# NOTICE OF DECISION

**PARTITION TENTATIVE PLAN / CLASS 3 SITE PLAN REVIEW CASE NO.: PAR-SPR24-13**

**SUMMARY:** Multi-family development of 60 units as Phase II of the Gussie Belle Commons.

**LOCATION:** 739 23rd St NE, Salem OR 97301

GUSSIE BELLE COMMONS: PHASE 2

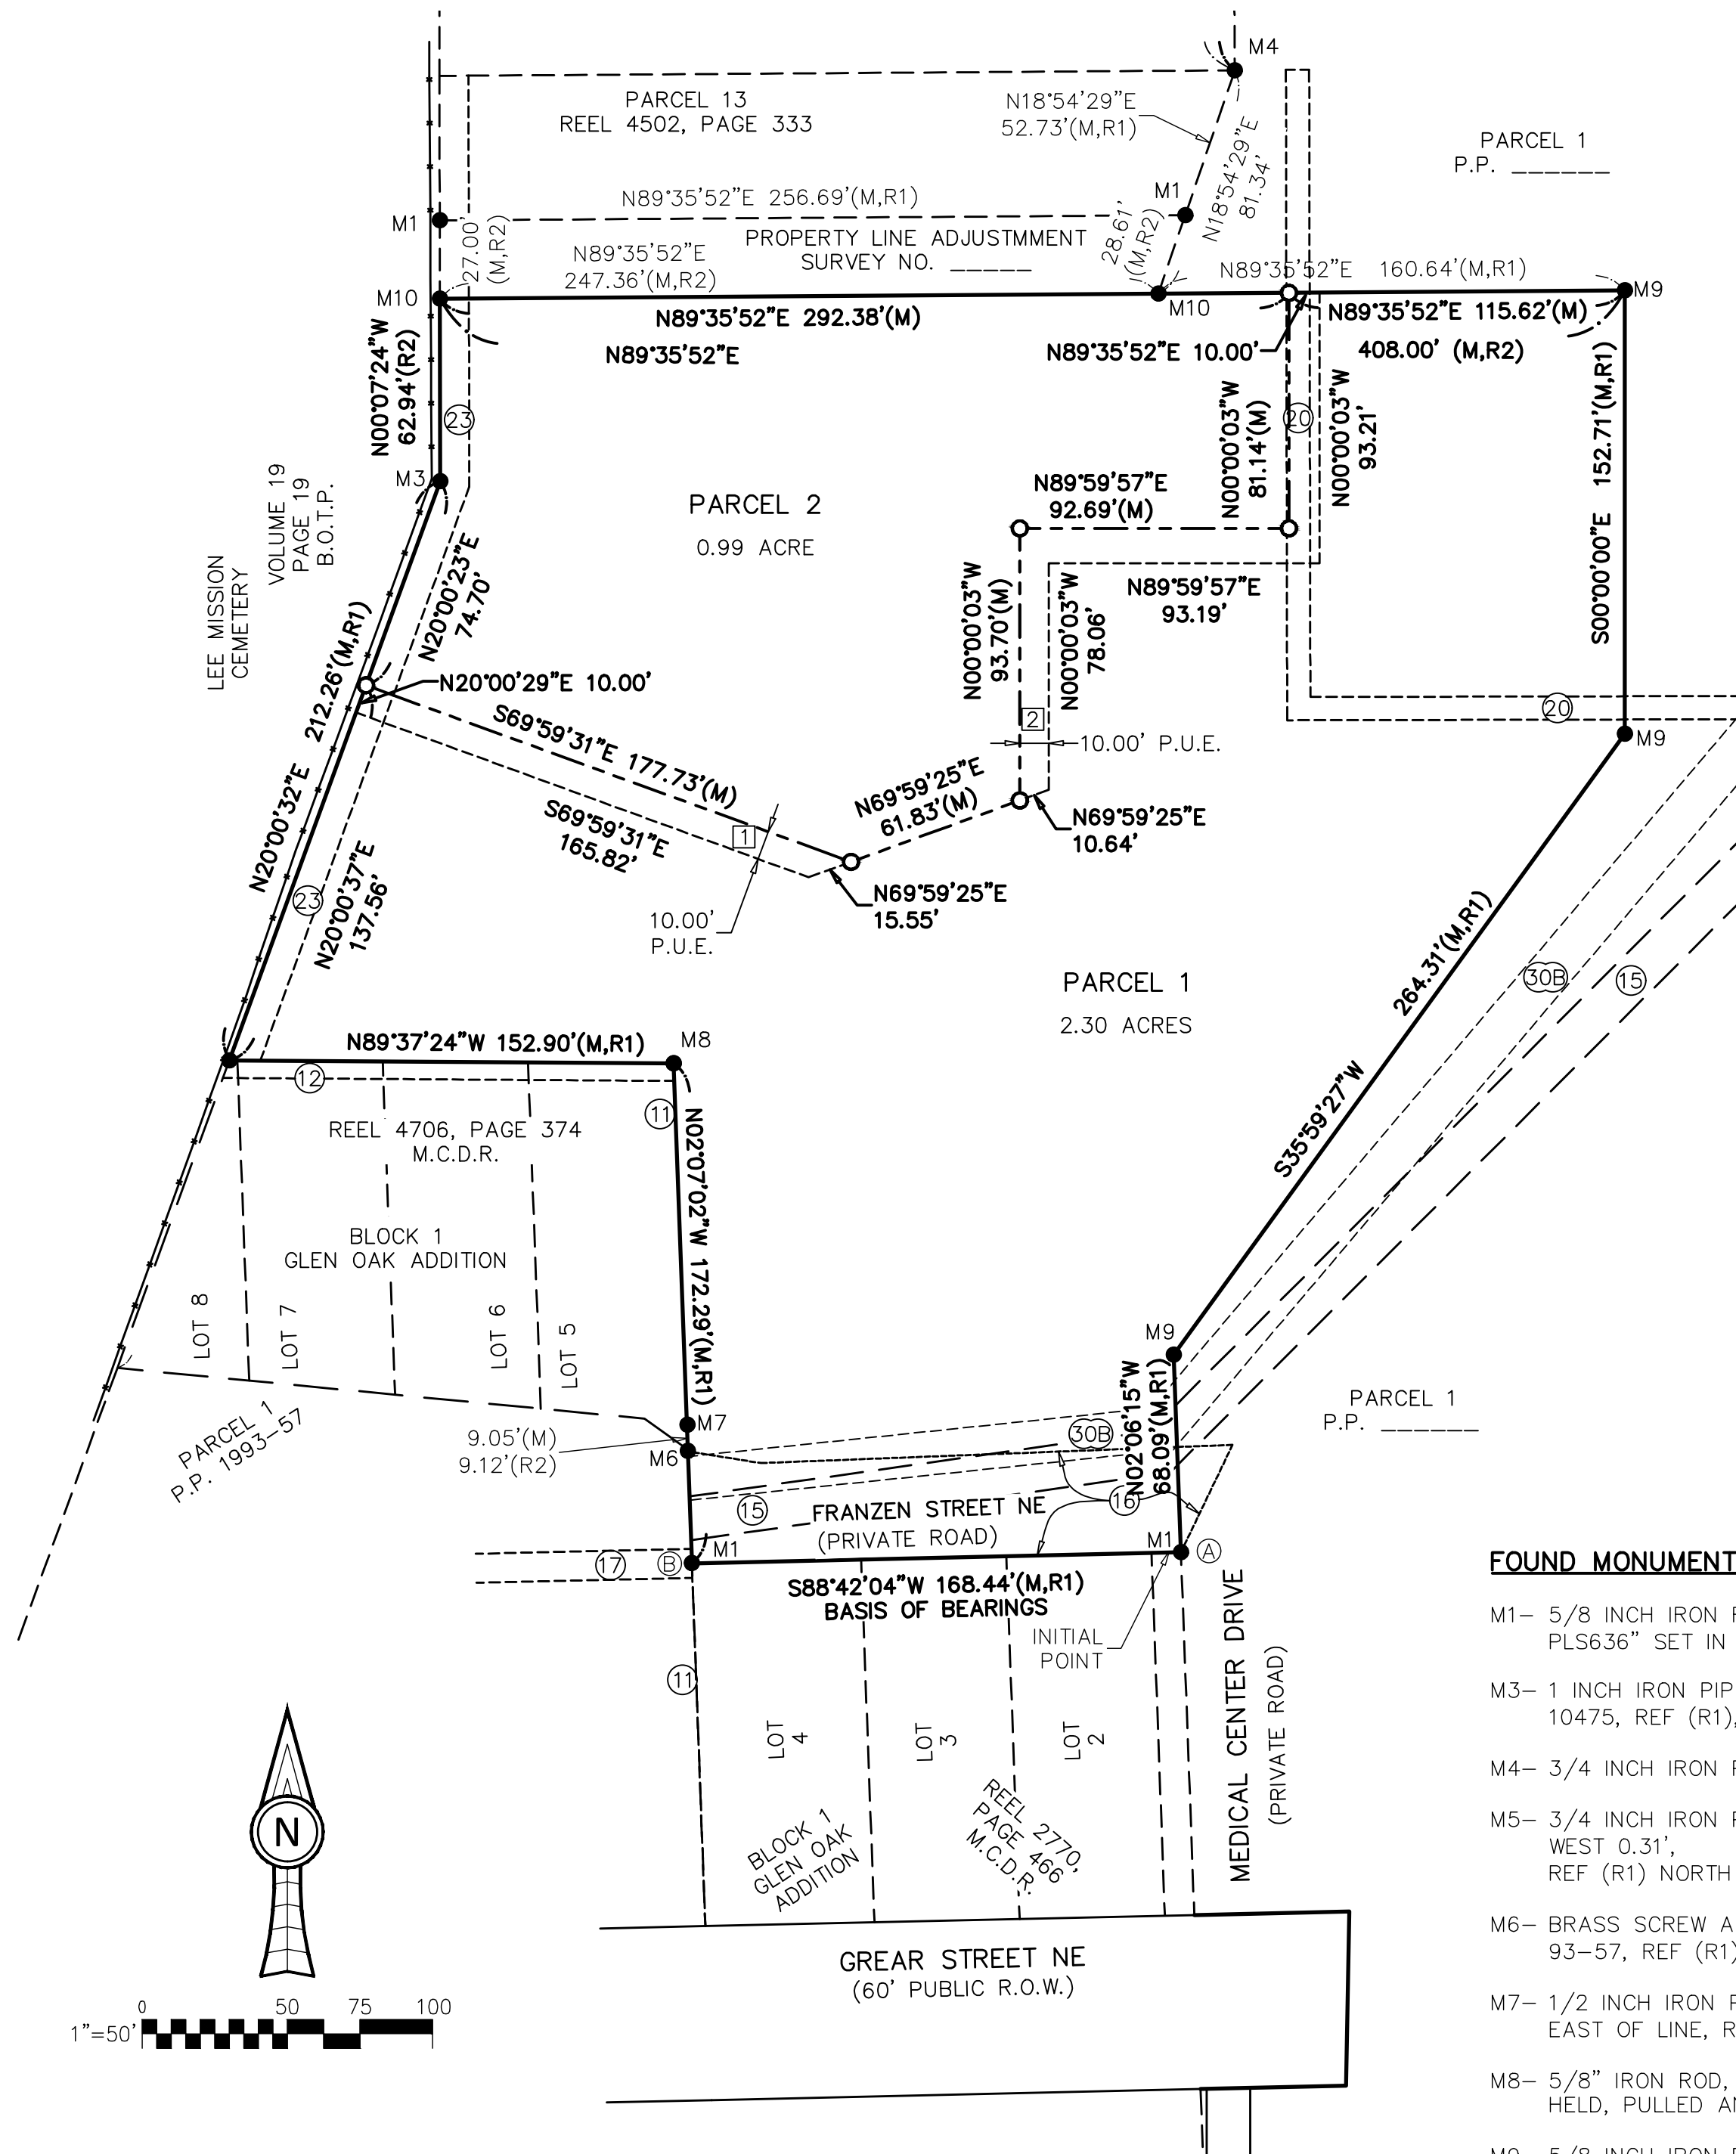
**Finding:** As shown on the tentative partition plan (**Attachment B**), the proposed partition divides the subject property into two parcels. Proposed Parcel 1 is approximately 43,000 square feet in size (2.30 acres) and proposed Parcel 2 is approximately 100,200 square feet in size (0.99 acres). Both proposed parcels exceed the minimum required lot size and dimension requirements. The subject property abuts Franzen Street NE which is a private local street approximately 165 feet long, thereby meeting the minimum street frontage requirement.

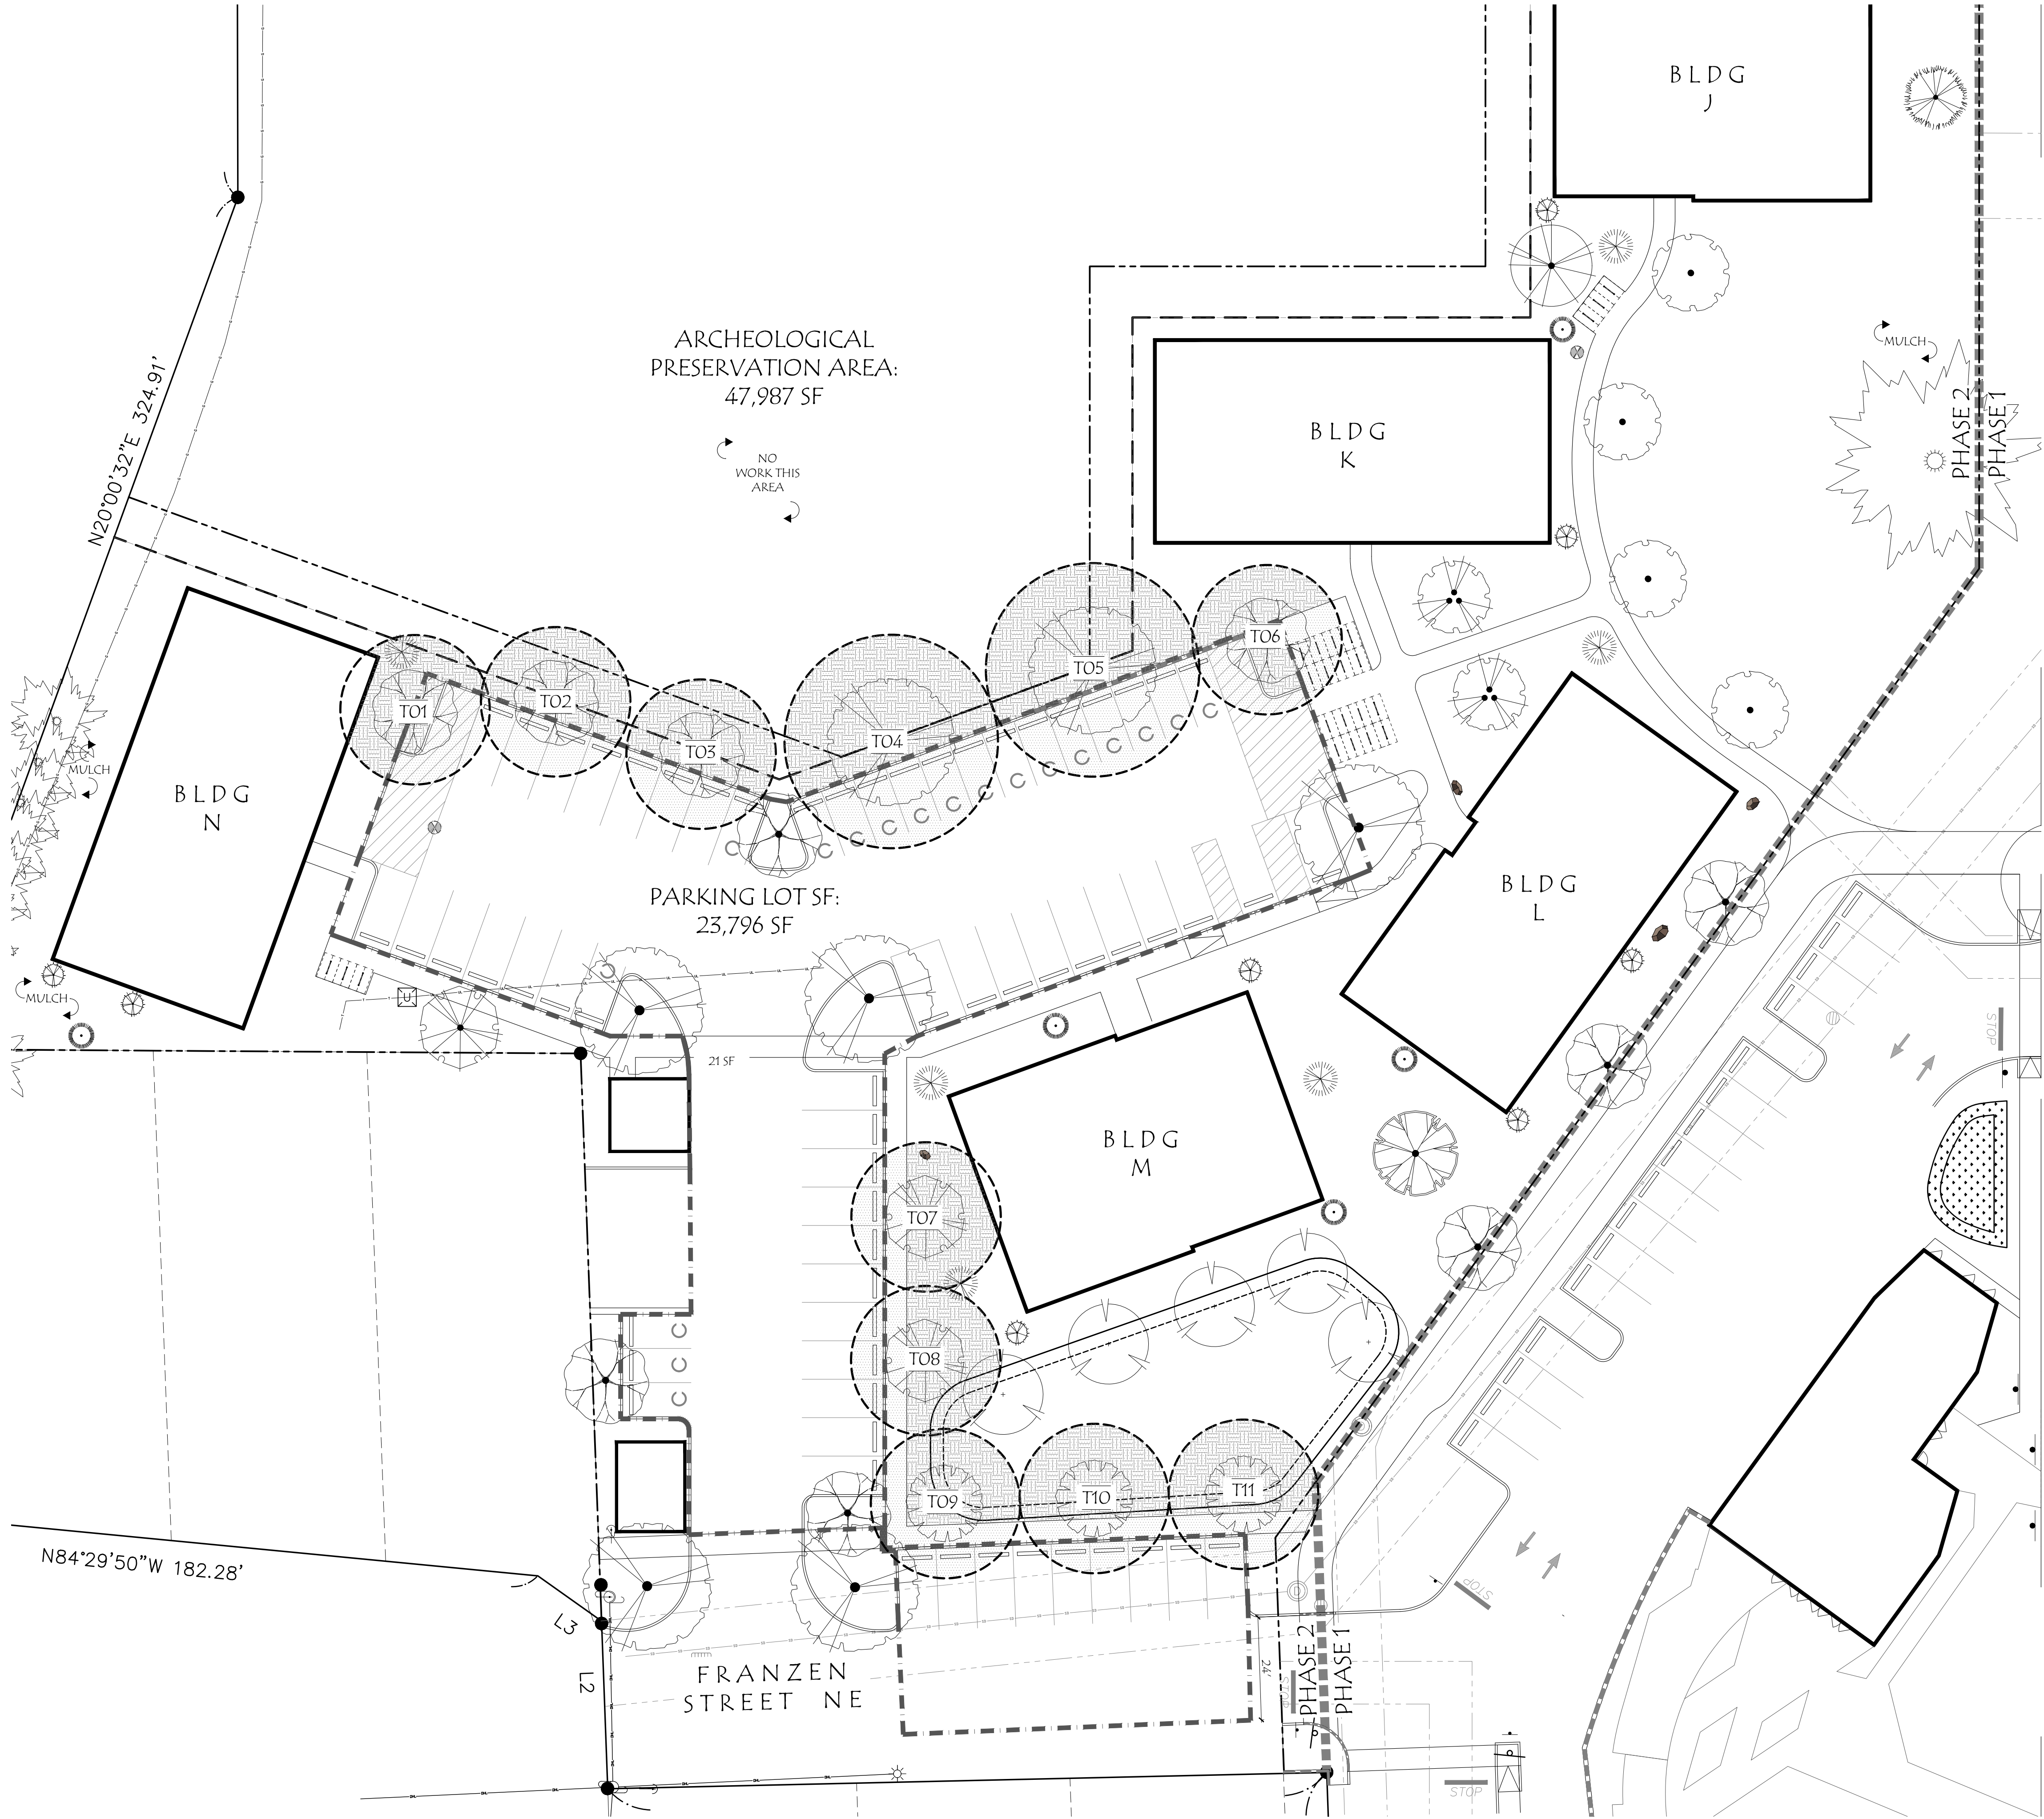
**Finding:** The development plans indicate 11 trees will be planted to meet the CFEC standards, using three types from Table 806-7; two of which have an expected 15-year tree canopy diameter of 50 feet, and nine with an expected 15-year tree canopy diameter of 35 feet. All except one tree (no. 8) near the southern parking area along Franzen Street NE will be planted within ten feet of the parking area. The trees in this area are behind a pedestrian sidewalk, and may need to be moved slightly closer to ensure the standard is met; therefore, the following conditions applies:

**Finding:** The development plans indicate all 11 trees will be planted in three separate areas where their expected 15-year tree canopy diameter will form a continuous canopy, in their respective locations, interrupted only by vehicle use areas or stormwater infrastructure, and do not overlap with the proposed building. All of the trees are proposed to be planted within groups of at least three trees per planter island, meeting the minimum required soil amount for each tree type per Table 806-7. These standards are met.

**Condition 11:** Prior to approval of landscape plans for the proposed development, the landscape plan shall be updated to ensure all trees planted to meet the climate mitigation requirements are located within ten feet of the parking area, and demonstrate compliance with all tree canopy standards in SRC 806.035(n)(3), including a continuous canopy for any revisions made.
